Re: Parramatta Powerhouse Heritage Impact Statement

The National Trust strongly object to the inadequate heritage impact assessment undertaken for St George's Terrace as part of the Parramatta Powerhouse proposal (SSD-10416).

The heritage impact of the revised design needs to be appropriately assessed as part of the planning process. The National Trust wishes to raise its concerns with the recently tabled *Addendum Statement of Heritage Impact – St George’s Terrace* (2 November 2020) prepared by Advisian.

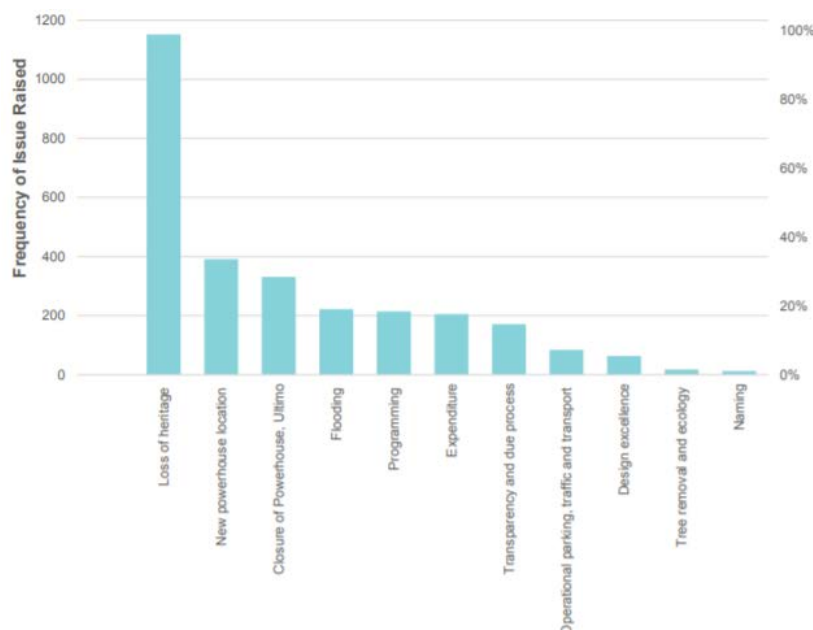
Photomontage of the “revised” Powerhouse Parramatta (Source: Moreau, Kusunoki and Genton, 2020). The structure, form and material of the building clearly bears no relationship to the remaining sections of St George’s Terrace. This is a bad outcome for both the historic building, and for the new structure in terms of design integrity.
